## Public Input No. 38-NFPA 22-2015 [ Global Input ]

**Proposal:** Delete the term “Standpipe” as it is not consistently used throughout the standard and is redundant with the term suction or gravity tank.

**Figure A.4.1.3**

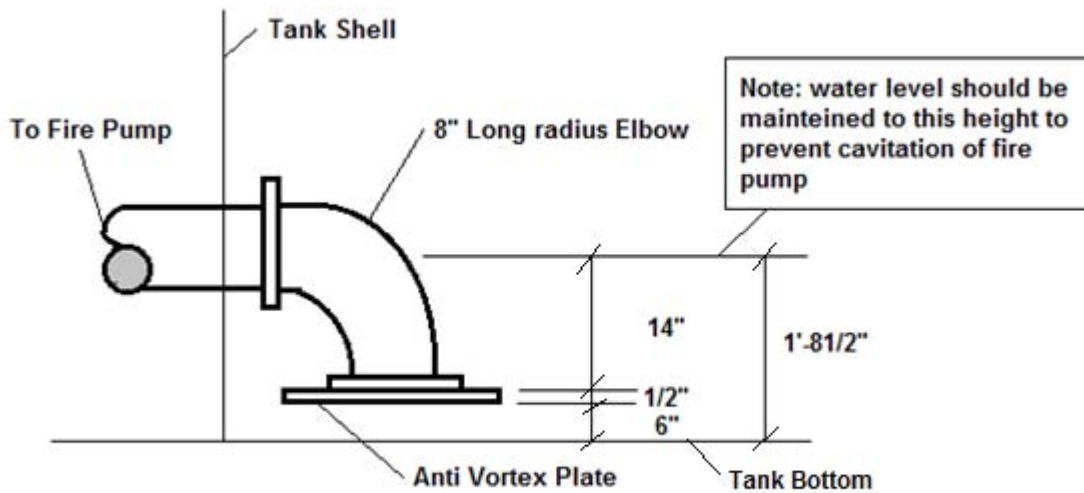
A.4.1.3 Careful consideration should be given to the determination of tank capacity. In addition to the required fire flow and duration requirements of water based system standards, the permitted fluctuations of the water level sensors (See Section 14.9) 12 in. (300 mm) below normal for evaporation and closure time for the fill valve and maintaining a reasonable amount of water in the bottom of suction tanks to prevent cavitation of fire pumps should be factored into the overall tank size.

Given a 1ft variation between the fill sensor and overflow connection 2349 gallons would have to be added to the tank capacity. Further assuming that the minimum water level should be approximately equal to the center line of the suction pipe (to prevent fire pump cavitation – see Figure A.4.1.3) then another 3948 gal should be added to the needed capacity.

The dimensions in Figure A.4.1.3 are based on a 1000 gpm fire pump which requires an 8" suction line. Dimensions for other sizes of pumps and suction lines will vary slightly.

**Statement:** Removes unenforceable language and provides clarification of the capacity requirements for all tanks. New annex language has been added to A.4.1.3 however, the proposed figure A.4.1.3 was not accepted as the standard already contains a figure of a vortex plate and piping, an additional figure may add confusion.

**Figure A.14.1.7.2.1 Dual Purpose Tank**

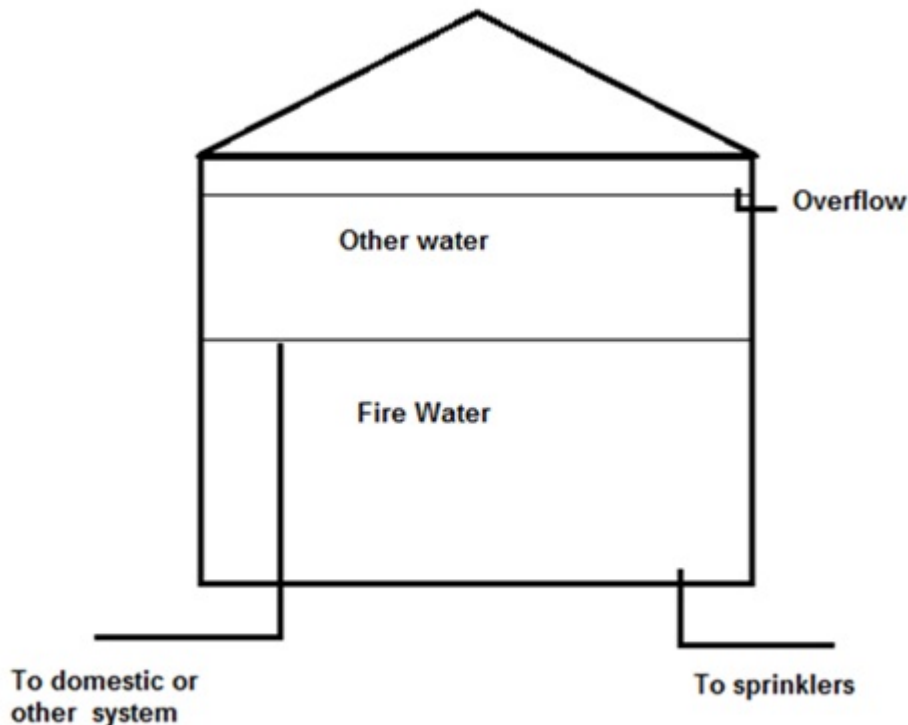
**14.1.7\* 8.2.1** Pipe used for other than fire protection purposes shall be entirely separate from fire-service pipes and shall extend to an elevation inside the tank ~~below~~ above that required ~~which an adequate quantity of water is constantly available~~ for fire protection.

**A.14.1.7.2.1** See Figure A.14.1.7.2.1.
